**Environmental
Protection Agency**

July 26, 2011

RE: MEDINA COUNTY
GRANGER TOWNSHIP
MUGRAGE COUNTY PARK
NPDES PERMIT NO. OHC000003
OHIO EPA PERMIT NO. 3GC05204*AG
CONSTRUCTION STORM WATER

Figure 1. There are no erosion and sediment controls present on site.

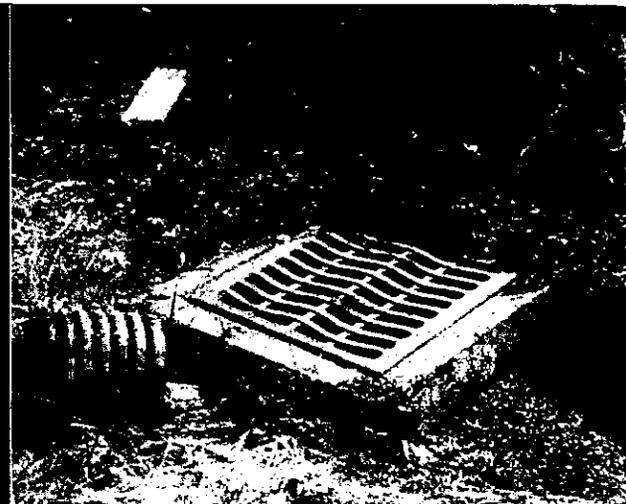
- **There are no erosion and sediment controls (ESC's) in place.**
 - ESC's must be implemented within seven (7) days of any earth disturbing activities (i.e. clearing, grubbing, grading, etc.). Please install ESC's immediately to prevent sediment laden runoff from leaving the site (See Figure 1).
